PLANNING & ZONING COMMISSION ZOOM MEETING
Monday October 16, 2023
City Council Chambers—515 N Main Ave
6:00 PM

HUXLEY, IOWA
HEDRICK
HEDRICK WAREHOUSE
SITE PLAN REVIEW

*Site Plan Information
Hedrick Warehouse Addition
104 Campus Avenue*

HEDRICK WAREHOUSE

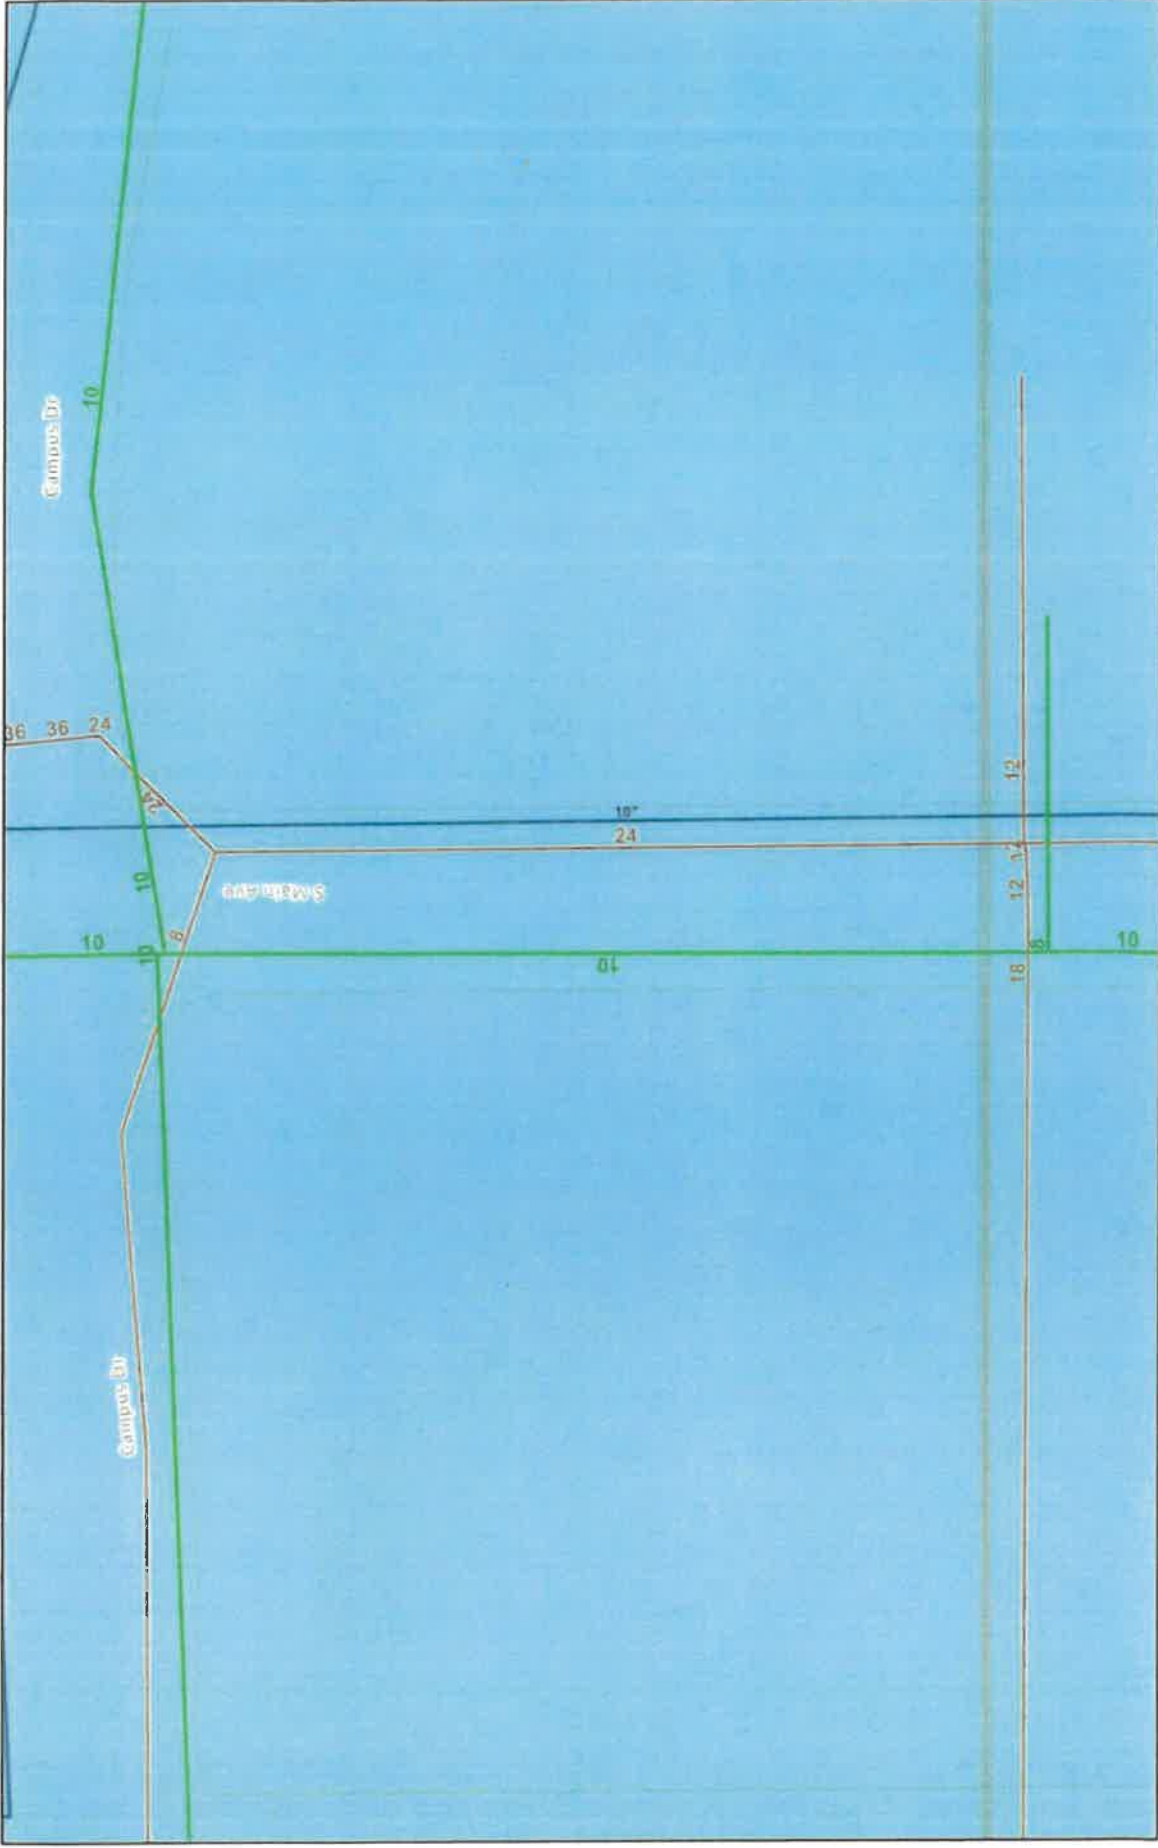
We have reviewed the Hedrick Warehouse site plan and find it acceptable.

This property does not have sidewalks along either Campus Drive or Main Avenue. The properties to the north, east and south of this property all have sidewalks. Consideration should be given to installing sidewalks on both sides of the property adjacent to both streets as part of the warehouse project.
